JOB: 1012.011-KUBARKY-DETAIL VT BRIDGE  
SHEET NO. SK 1 OF  
CALCULATED BY: RHC DATE: 8/5/05  
CHECKED BY: JMB DATE: 8/23/05  
SCALE: 1:100

PIER PLAN  
SCALE= 1:100

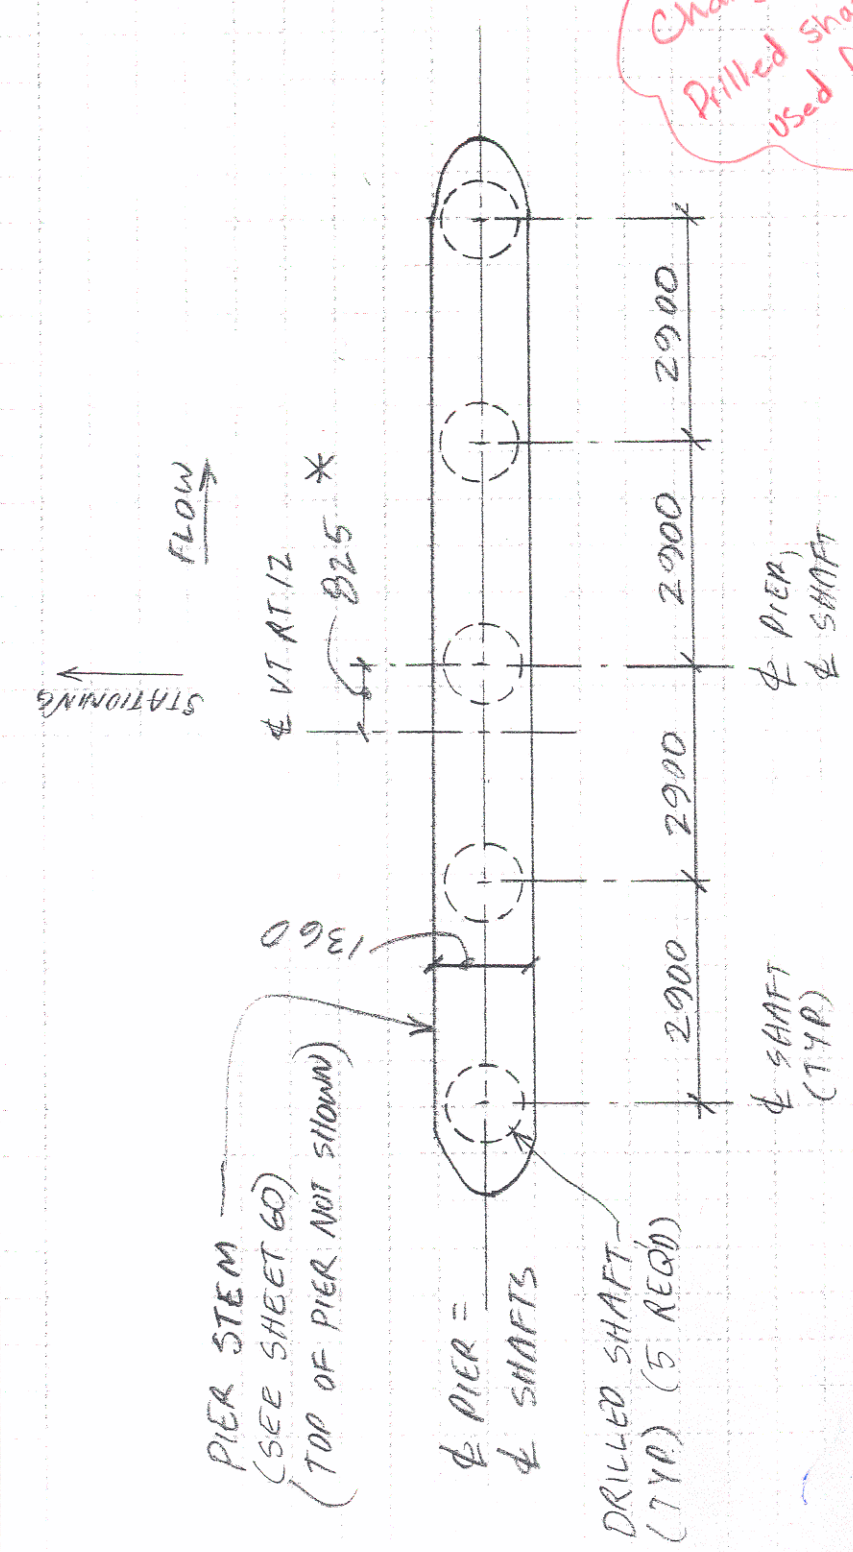
*Change of Design  
Pilled shafts were  
used for the pier*

\* NOTE: A DIMENSION ERROR SEEMS TO EXIST ON THE CONTRACT DRAWING SHEET 60 REGARDING PIER LENGTH AND LOCATION OF VT RT12 CENTRALINE. KUBARKY AND VART SHALL VERIFY THAT 825 DIMENSION SHOWN ABOVE IS CORRECT, AND SHALL CONSULT WITH B&L IF IT IS NOT.
